Product / Process Change Notification (PCN)							
<input checked="" type="checkbox"/> Major Change <input type="checkbox"/> Minor Change							
PCN Number: PCN_WPME-FISM_1779205141_20250120 Affected Series: WPME-FISM Affected Part Number: 1779205141 PCN Date: 2024-12-20 (YYYY-MM-DD) Effective Date: 2025-01-20 (YYYY-MM-DD)	Change Category: <input checked="" type="checkbox"/> Equipment/Location <input checked="" type="checkbox"/> General Data <input checked="" type="checkbox"/> Material <input type="checkbox"/> Process <input checked="" type="checkbox"/> Product Design <input checked="" type="checkbox"/> Shipping/Packaging <input checked="" type="checkbox"/> Supplier <input type="checkbox"/> Software						
Contact: Product Management Phone: +49 (0) 7942 - 945 5001 Fax: +49 (0) 7942 - 945 5179 E-Mail: pcn.eisos@we-online.com	Datasheet Change: <input checked="" type="checkbox"/> Yes <input type="checkbox"/> No Attachment: <input checked="" type="checkbox"/> Yes <input type="checkbox"/> No						
DESCRIPTION OF CHANGE: <p>Due to an improvement of the production capability, Würth Elektronik eiSos has shifted the production of the affected part number to a new factory location.</p> <p>Wit

PHYSICAL DIMENSIONS

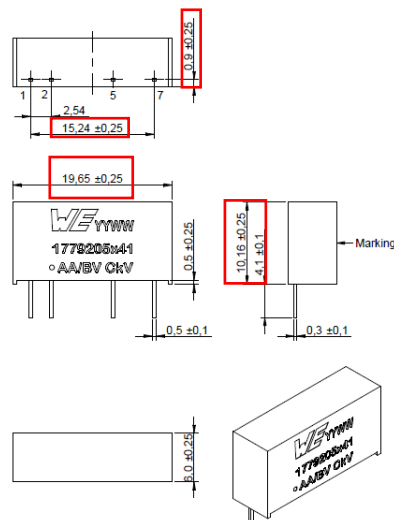
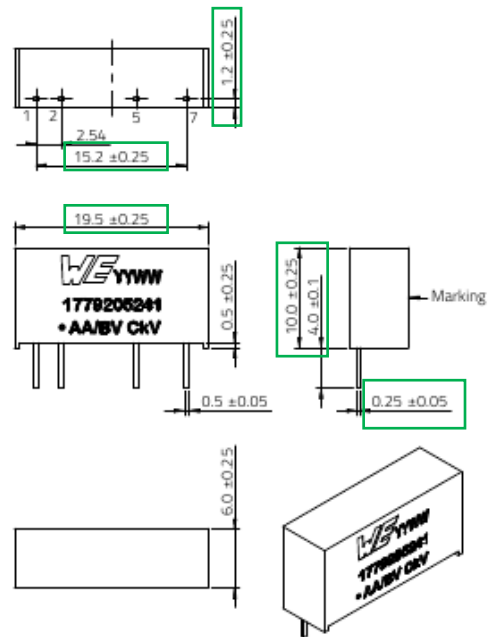
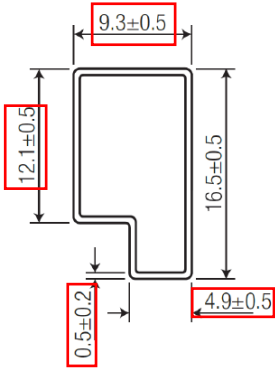
The mechanical dimensions have been updated based on new production. SIP-7 package shapes stay the same but with slightly deviated package length and height.
